# LPS/LinkOn Duty Cycle

Yasumasa Hasegawa  
Sony Corporation

## Recommended changes

Fig. 1 Isolation circuit for LPS

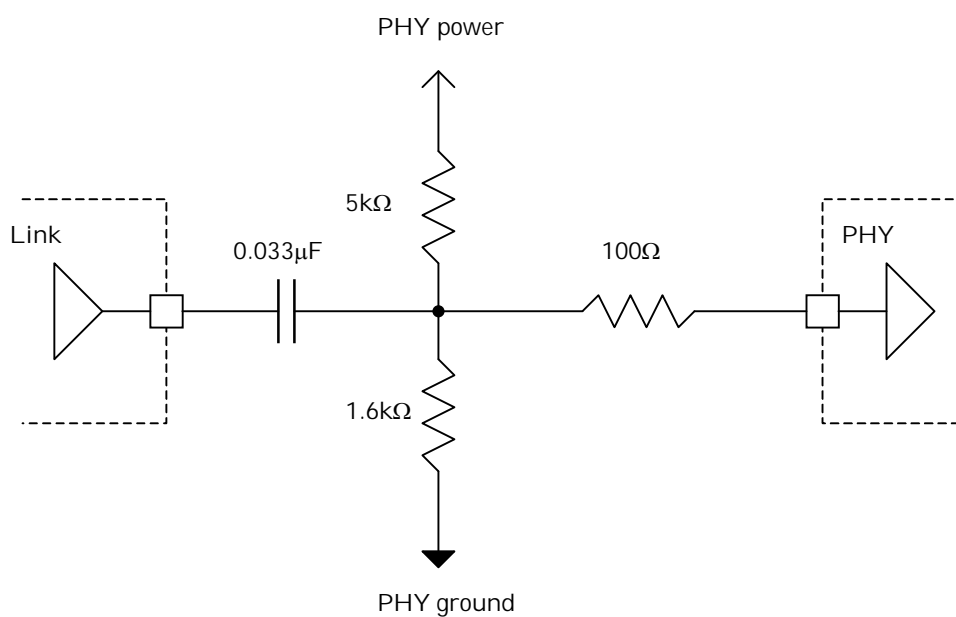
As depicted in Fig.1, the imbalanced bias scheme is employed for the LPS and the LinkOn. The isolation circuits for LPS and LinkOn are basically identical, so we take the LPS as an example. If the Link (in this case) stops “pulsing” in any logical state, the voltage at the receiver’s end (the PHY in this case) finally settles at the bias voltage. Owing to its lower bias voltage, the PHY observes logical zero in this case. While providing the advantage of the usability of standard CMOS driver/receiver combination, it imposes a careful design consideration since the received high level of the signal only reaches 70 – 80% of the receiver’s Vdd. A supply voltage difference between the PHY and the Link makes the situation even worse.

Fig. 2 Signal waveform at the receiver (**50%** duty cycle, in the steady state condition)

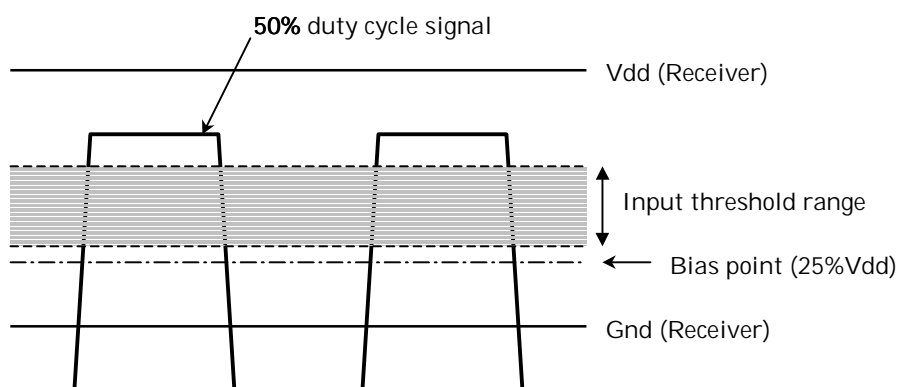
Fig.2 illustrates the received signal waveform when the duty cycle is 50%.

Fig. 3 Signal waveform at the receiver (**25%** duty cycle, in the steady state condition)

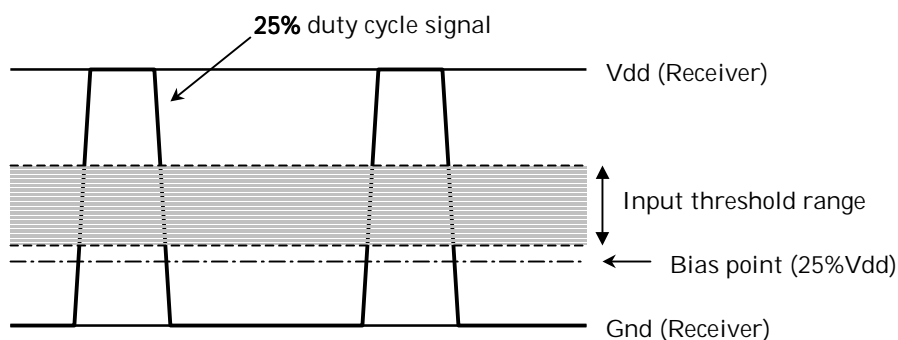
As depicted in Fig. 3, on the other hand, if the signal duty cycle is 25%, a 75% of the total pulse height appears above the bias voltage level. Assuming 25% Vdd bias (as illustrated), the received signal swings pretty much the same as direct CMOS interface (i.e., the high level reaches receiver's Vdd).

It is easily noticed that, if “large” duty cycle is used instead, the received signal tends to be even lower voltage. This implies that the DC margin for the logical high level would be eaten up.
